# 7-ELEVEN

STORE #38421

STATE HIGHWAY NO. 66 & WILLOW BEND  
ROCKWALL, TEXAS 75087

"RECORD DRAWINGS"  
These drawings have been revised to show changes during the construction process reported by the contractor to Evolving Texas and considered significant. This drawing is not guaranteed to be "As Built", but is based on visual inspection and the information available and provided to Evolving Texas  
Date: 10/9/2019 By: *Samantha D. Renz*

Storm Drain P&P  
 Line A

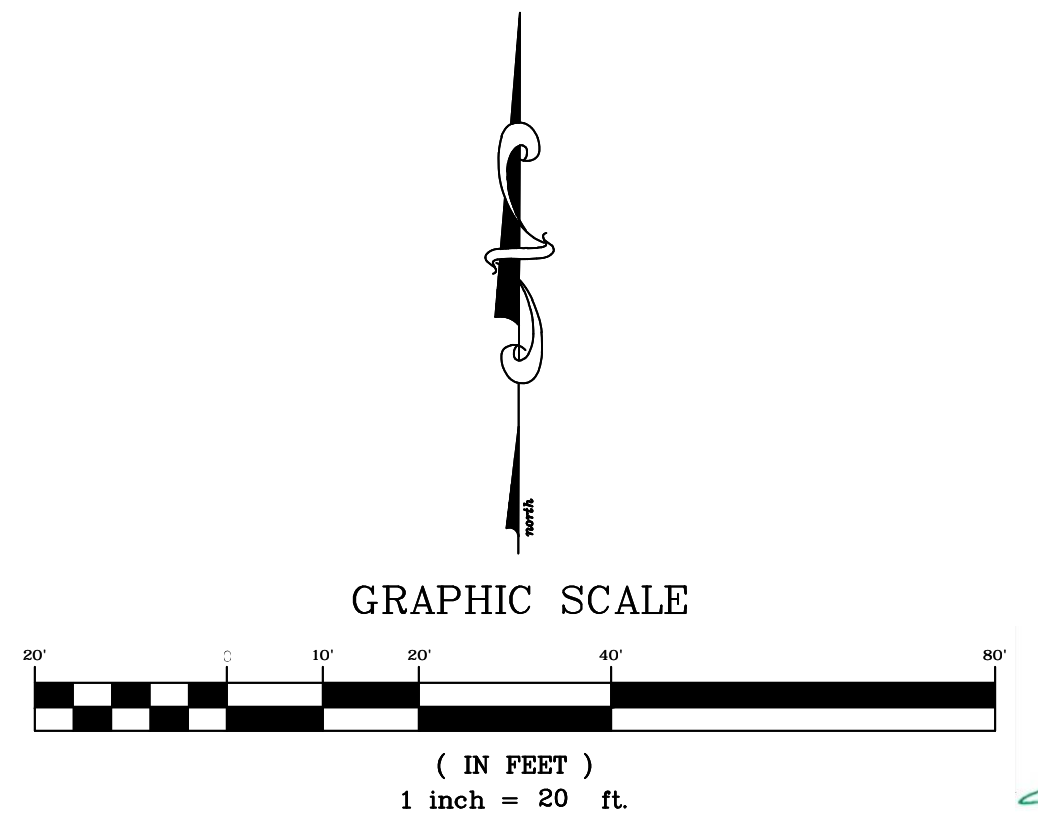
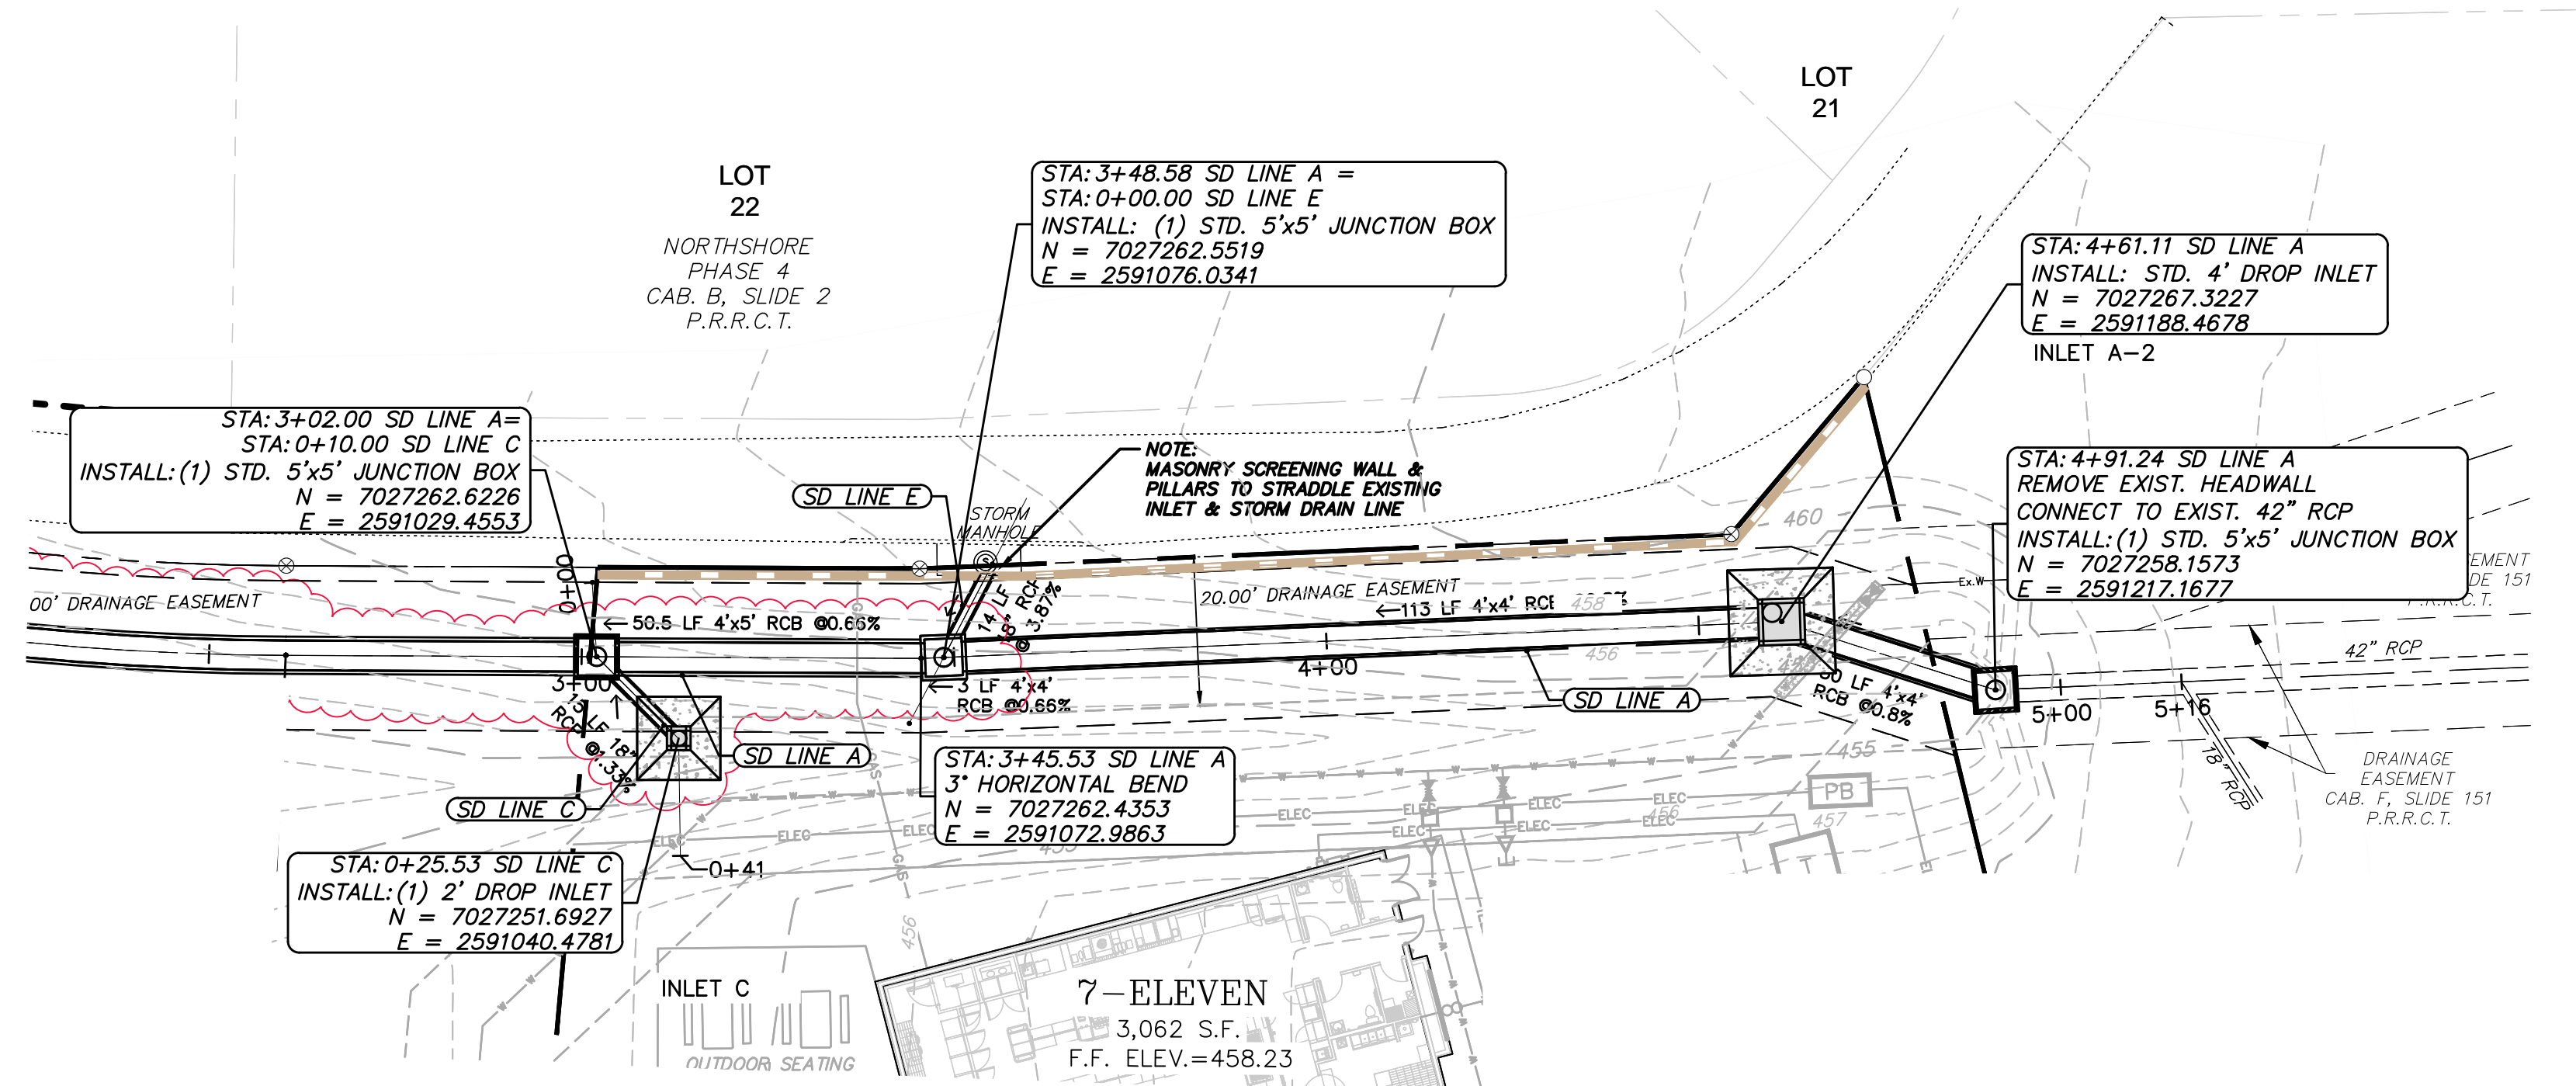
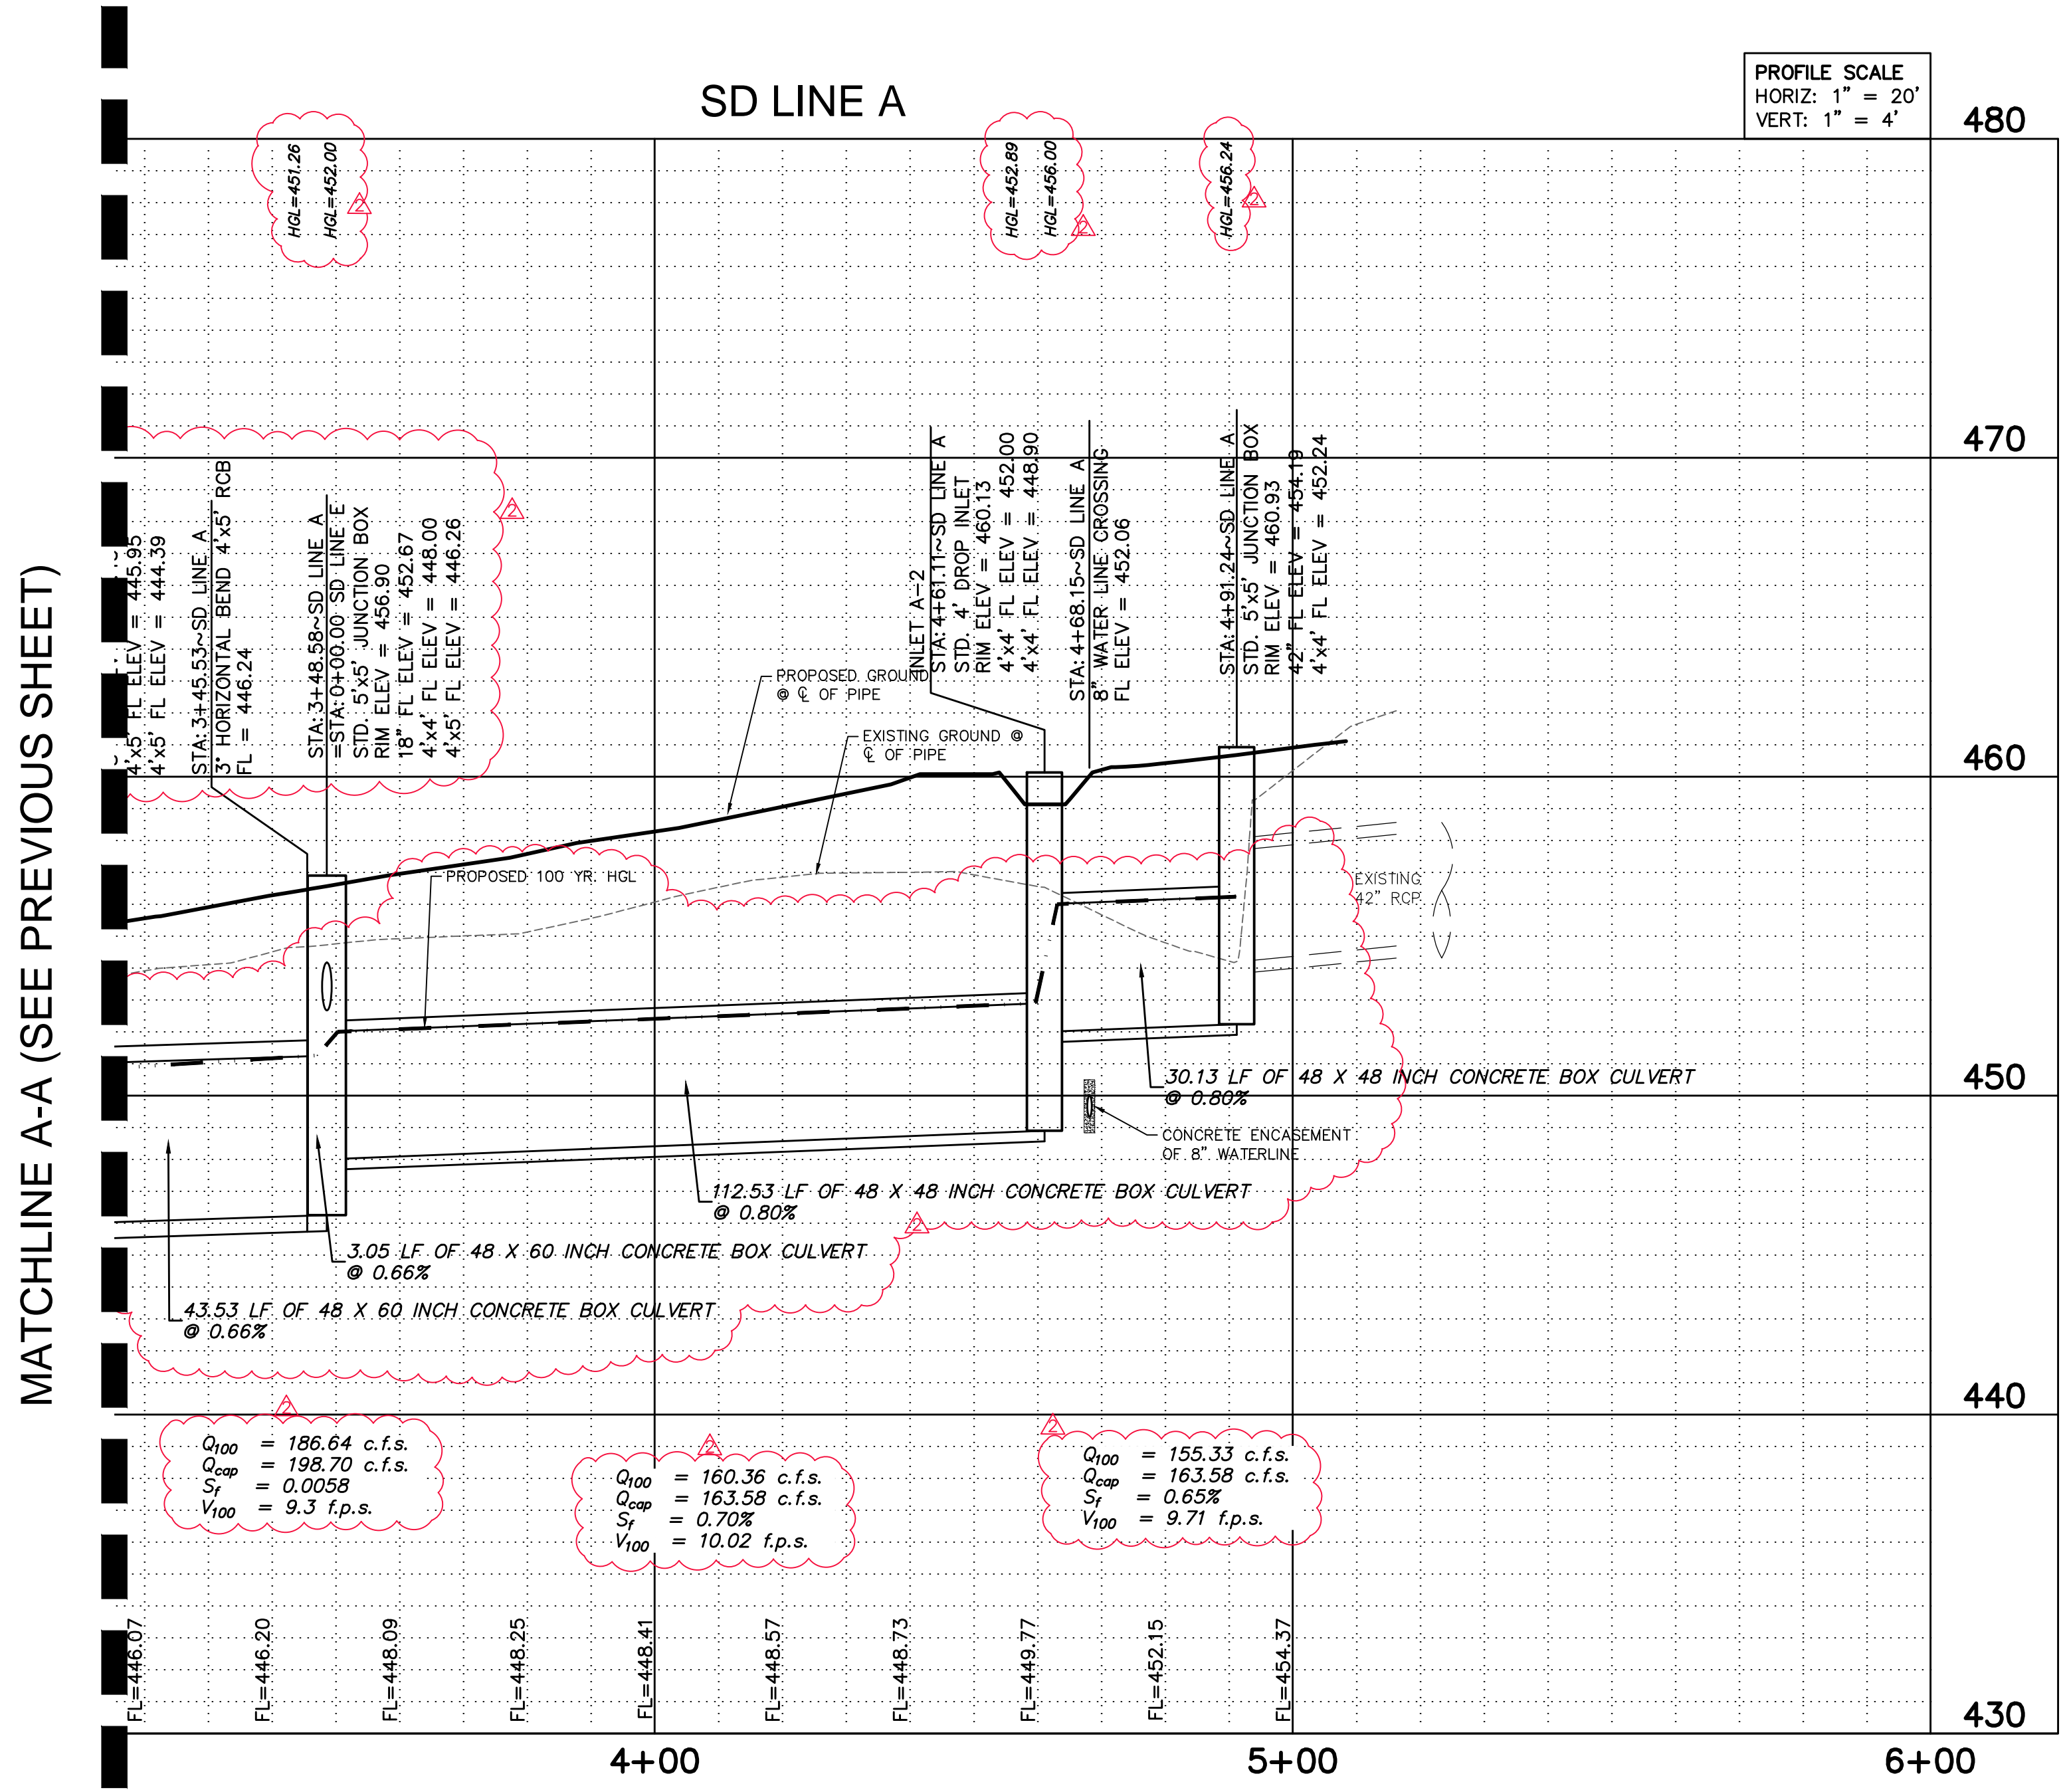
NO.	DATE	COMMENTS
1	1/21/19	Revised box culvert size to 4'x4' and HGL
2	2/7/19	Revised box culvert size from 4'x4' to 4'x5' and HGL
